MODELS 61, 66, 266, 268, 272, 268 K

NEW STARTER COMPL. AS A SPARE PART REF. NO. 503 61 55-71

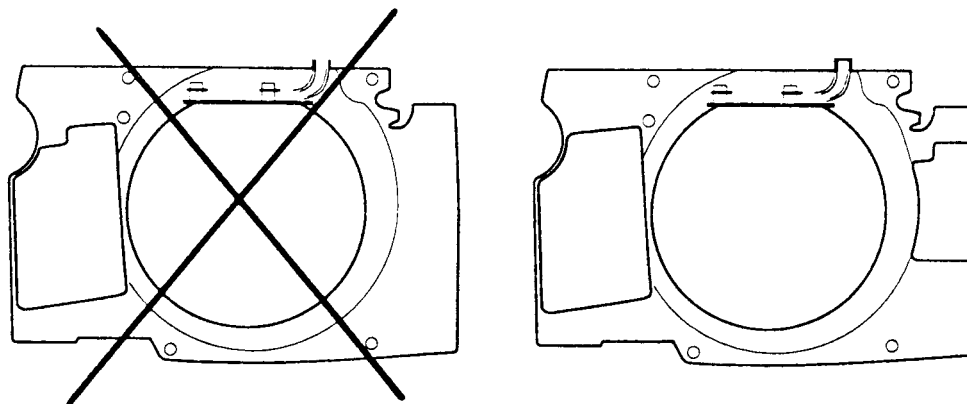
When we introduced the new starter with a so called golf club design on the model 272, a co-ordination is also done.

In order to use the new starter compl. to all the models above, the following is valid:

1. The air conductor Ref. no. 501 65 92-01 for the models 268/272 is modified in order to fit also saws with SEM ignition system, i.e. the models 61, 66 and 266.

2. In the starter compl. with new Ref. no. 503 61 55-71, the modified air conductor Ref. no. 501 65 92-01 is included. The new starter therefore fits also on the models 61, 66 and 266. Starter compl. without an air conductor is excluded.

In order to prevent the pulley from touching the flywheel, the new starter Ref. no. 503 61 55-71 must not be used together with the air conductor Ref. no. 501 52 61-01.

The reverse case is valid for the excluded starter compl. Ref. no. 501 77 67-02 with the pulley Ref. no. 503 10 24-02. In order to prevent a too little engagement between pulley and starter pawls, these parts must not be used together with the air conductor Ref. no. 501 65 92-01.
